# NOTICE OF PREPARATION (NOP), NOTICE OF COMPLETION (NOC), INITIAL STUDY, AND NOP COMMENT LETTERS

**Subject: Notice of Preparation of an Environmental Impact Report (EIR) pursuant to the Requirements of the California Environmental Quality Act (CEQA) for the Portuguese Bend Landslide Mitigation Project**

**Project Title:** Portuguese Bend Landslide Mitigation Project

**Figure 1**  
Portuguese Bend Landslide Mitigation  
Project Site Location

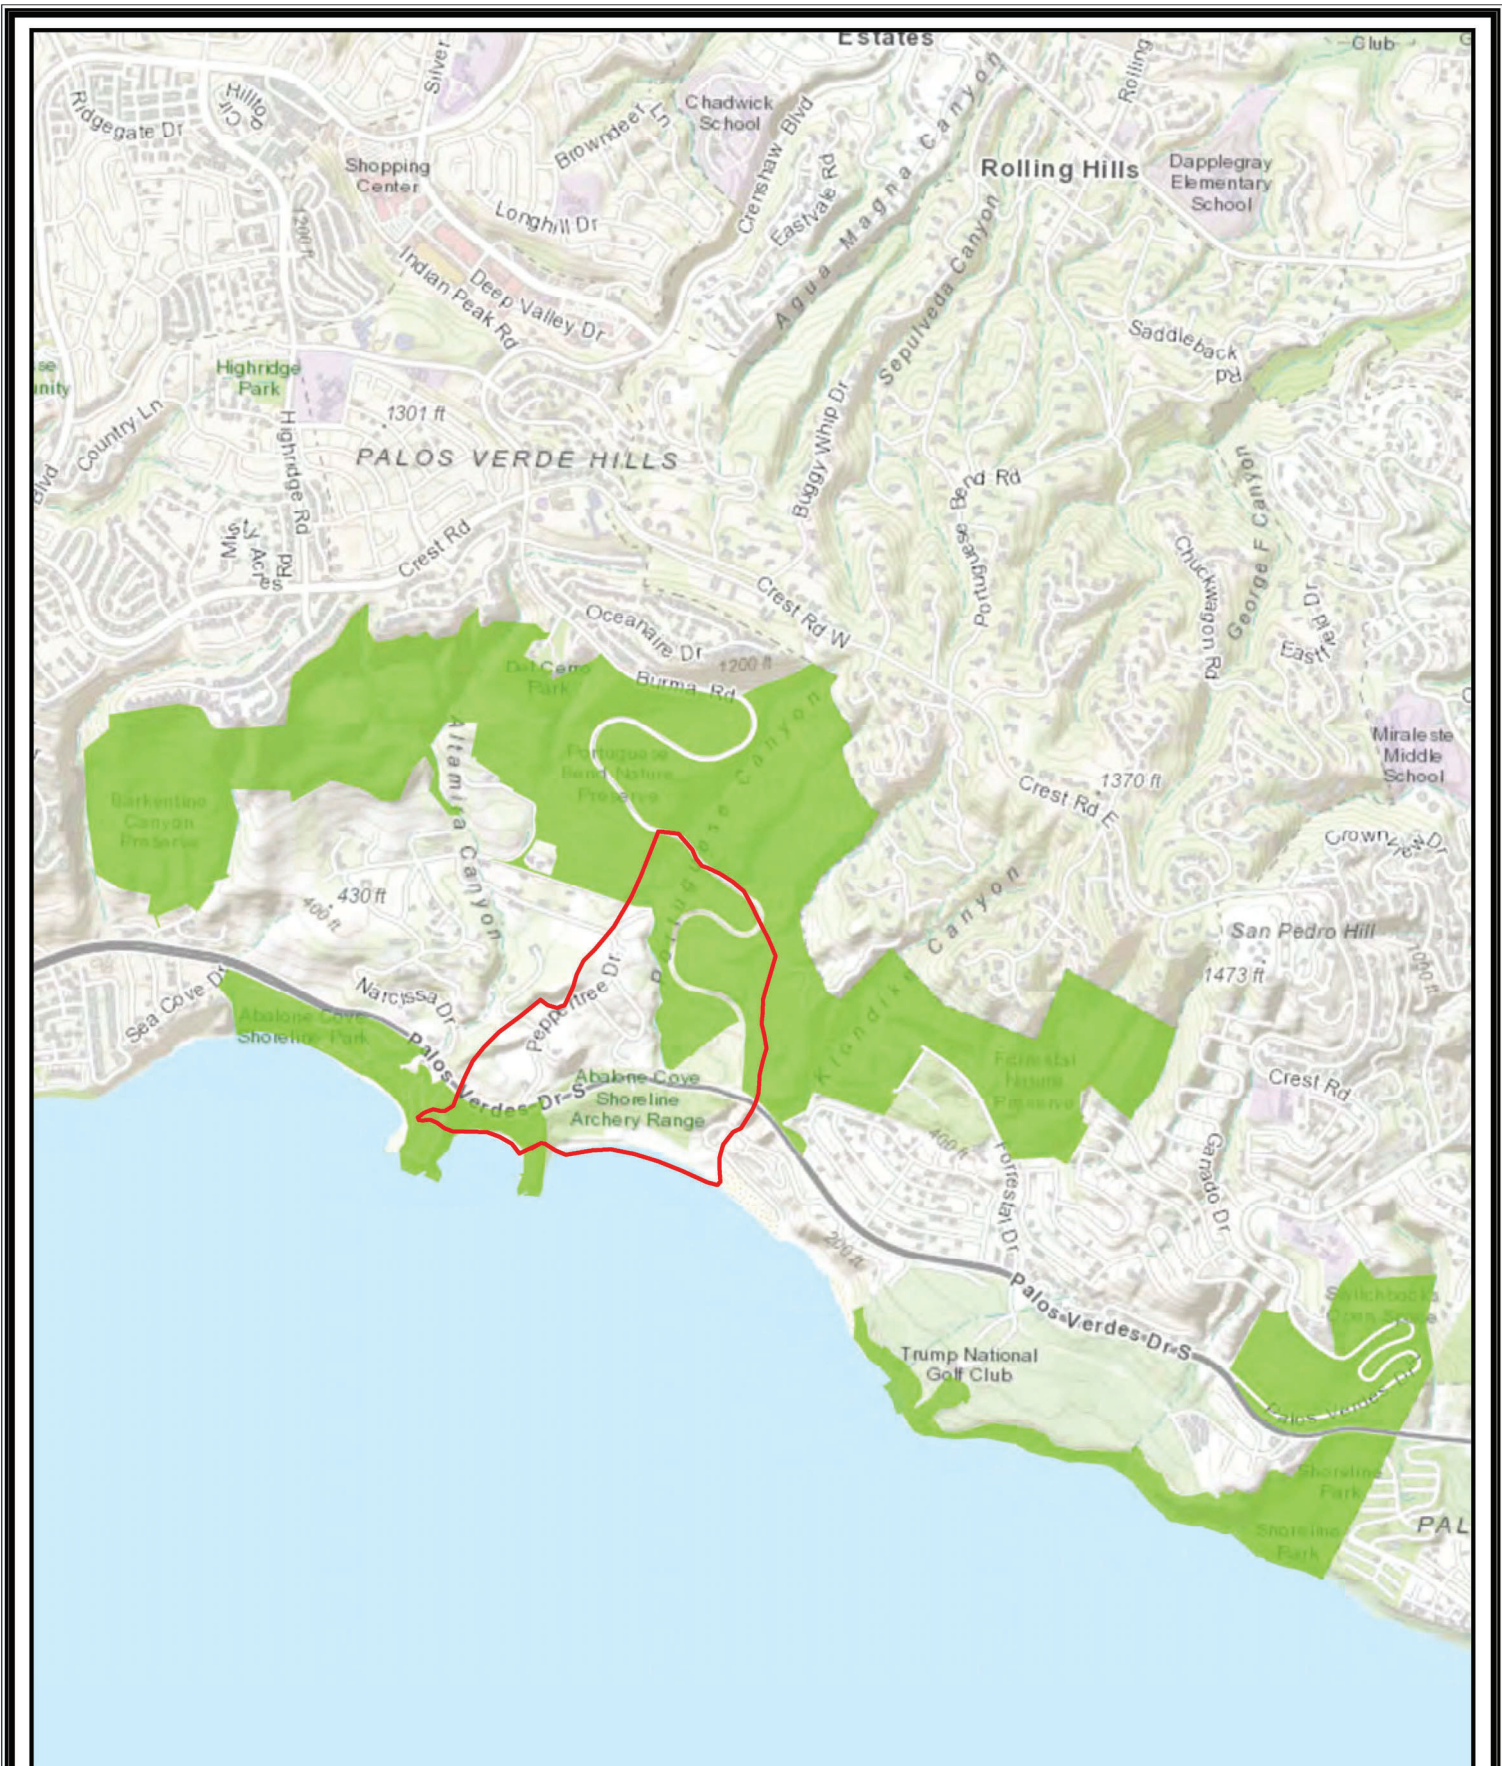
Figure 1 (as well as all other figures) shows a project area that excludes most of Abalone Cove Shoreline Park and is inconsistent with the project description.

1.1. Expand the project boundary to provide a margin of 180 feet along the easterly (up-slope) side of Burma Road Trail. (Portuguese Bend Mitigation Project, Nov. 2020, Chambers Group, Section 1.2, p. 5 and Figure 1, Project Site Location)

**Figure 2**  
 Portuguese Bend Landslide Mitigation  
 Palos Verdes Peninsula Conservancy Areas

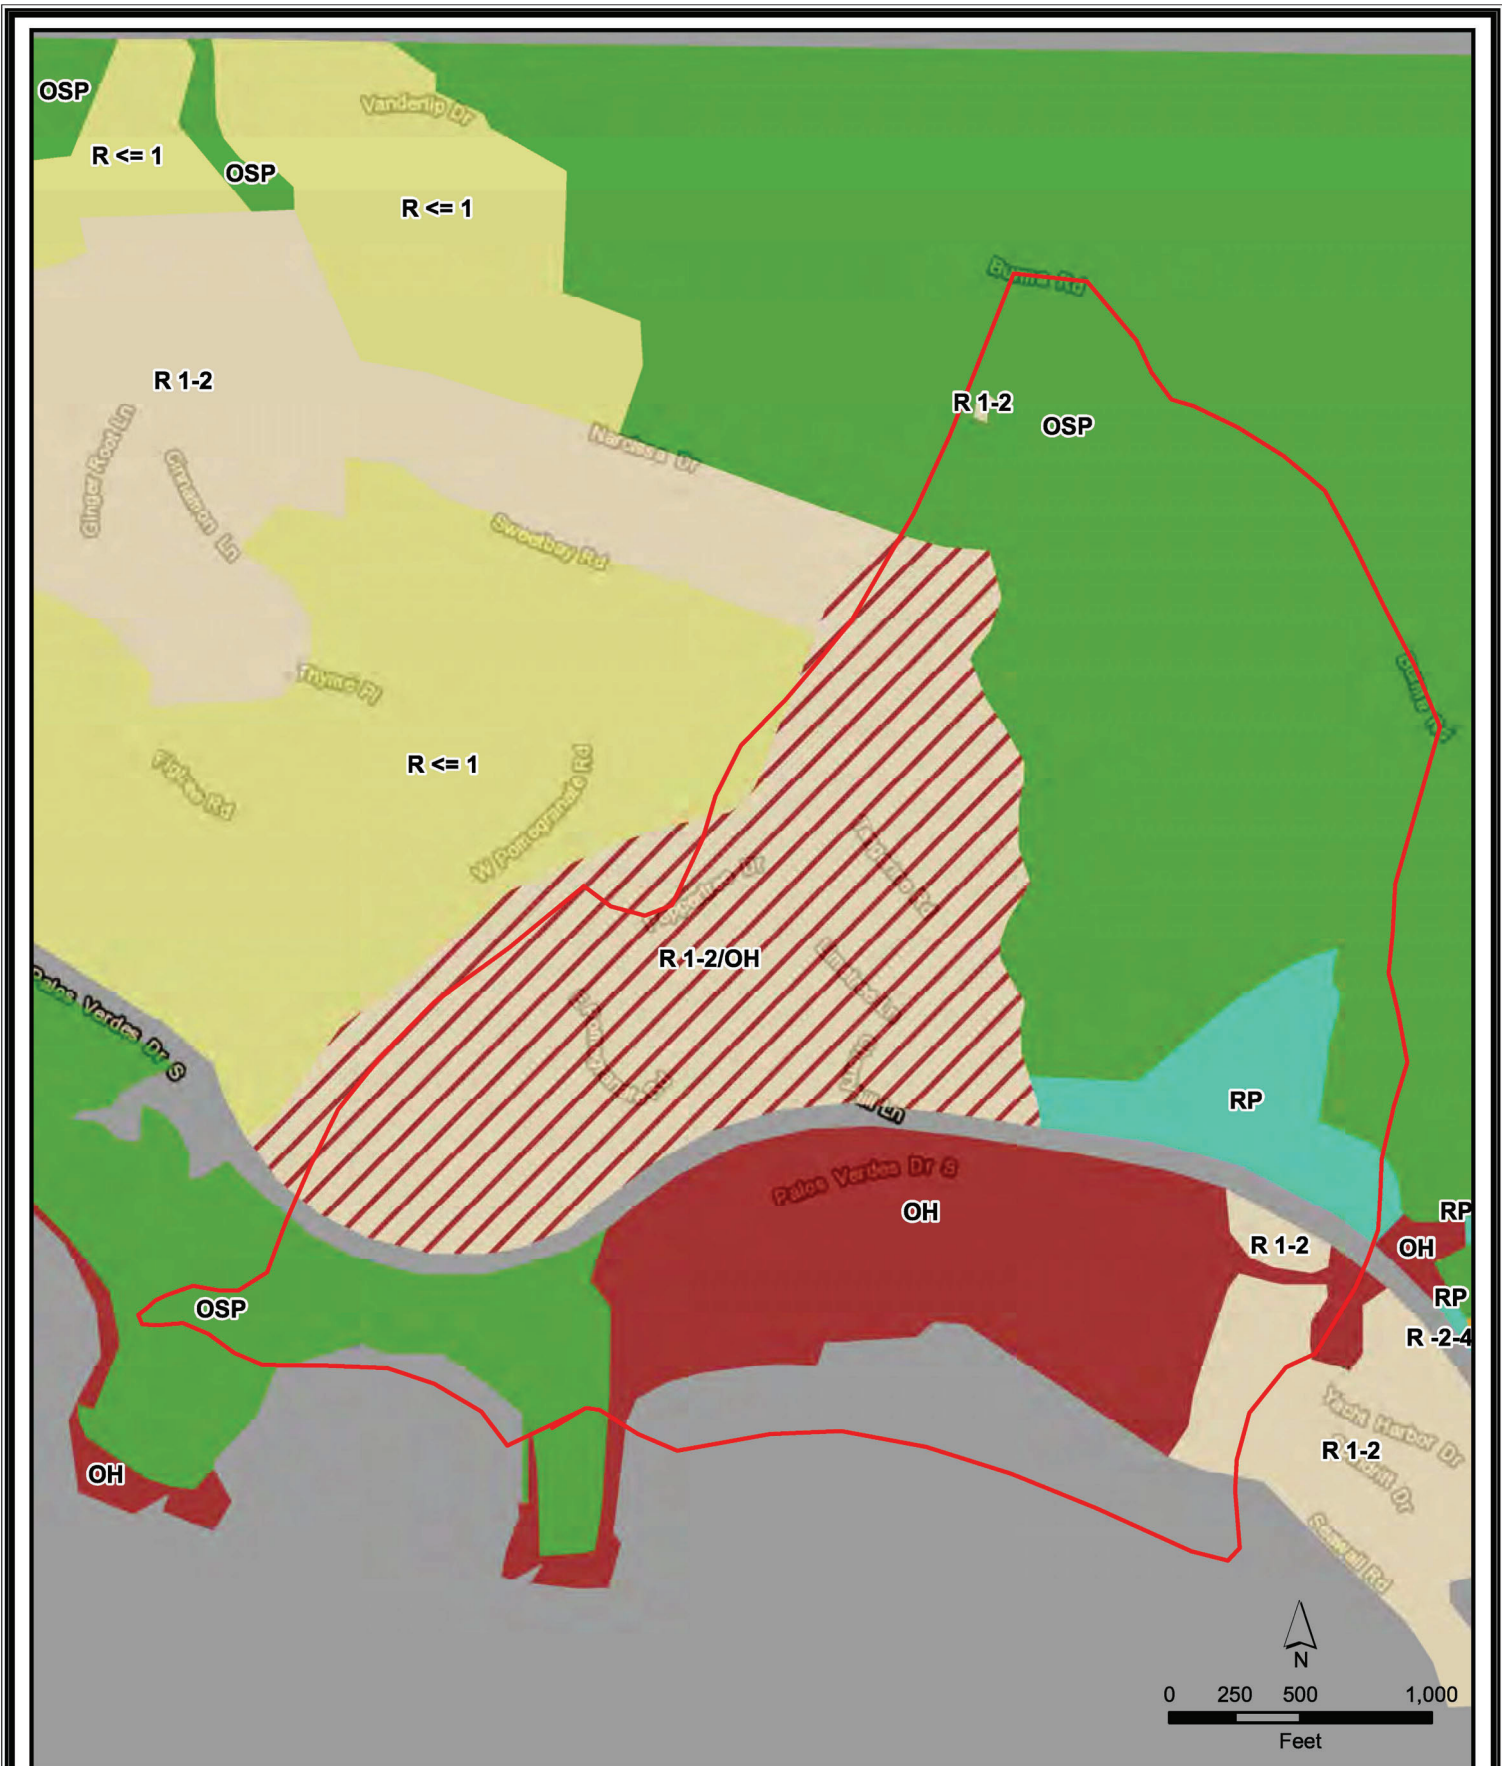
The Initial Study (IS) seems to underplay the importance of the NCCP. The map in Figure 2 shows "Palos Verdes Conservancy Areas" rather than identifying the area shown as land covered under the NCCP.
